From: Jan Hoover
Sent: Tuesday, September 23, 2014 11:45 AM
To: service@anjerinc.com
Cc: Jerry Clontz
Subject: PosiLift Plumbing Schematic
Attachments: 20140923 M210248 Mark Up.pdf

Attached is the plumbing drawing for the PosiLift on you trailer. It has three pages which I marked up to indicate what changes need to be made. You will need the following parts available:

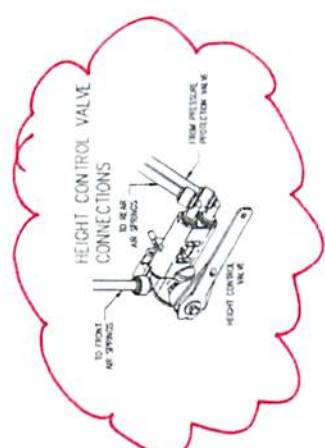
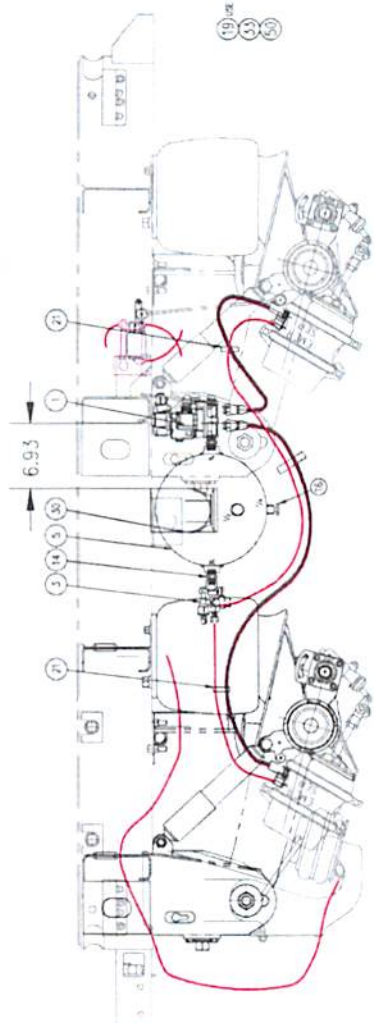
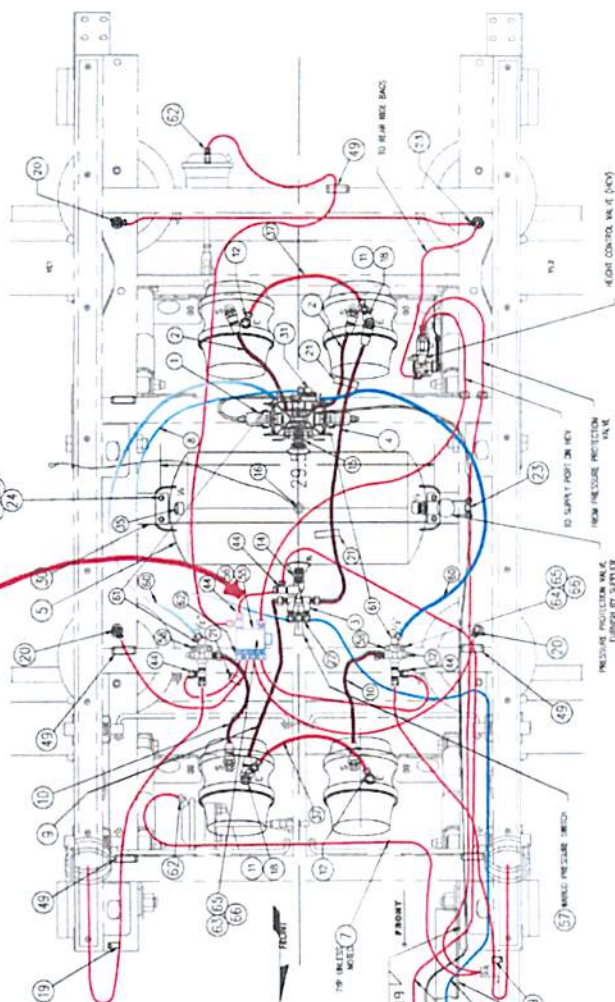
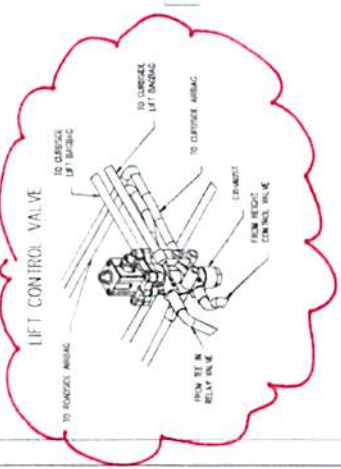
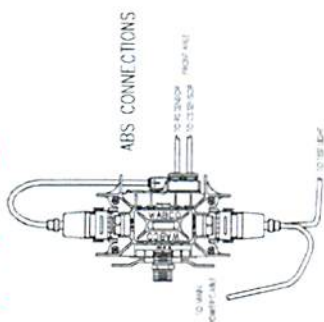
- 1) One male connector – 3/8 NPT – 3/8 TUBE
- 2) One union tee – 3/8 TUBE – 3/8 TUBE – 3/8 TUBE
- 3) Approximately 3 ft of synflex/nylon tubing.
- 4) Will most likely need the guts of one fitting (ferrule, etc) for the PosiLock line being relocated to the tee in the spring brake relay valve.

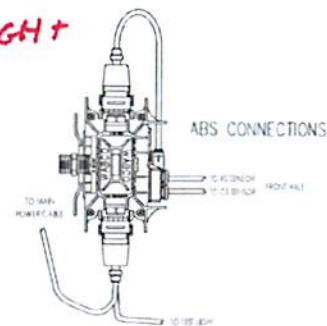
ADD 3WAY TUBE
TEE FITTING ON
DOWNSTREAM SIDE OF
THE PRESSURE PROTECTION
VALVE

ADD 3/8 SYNFLUX TUBING
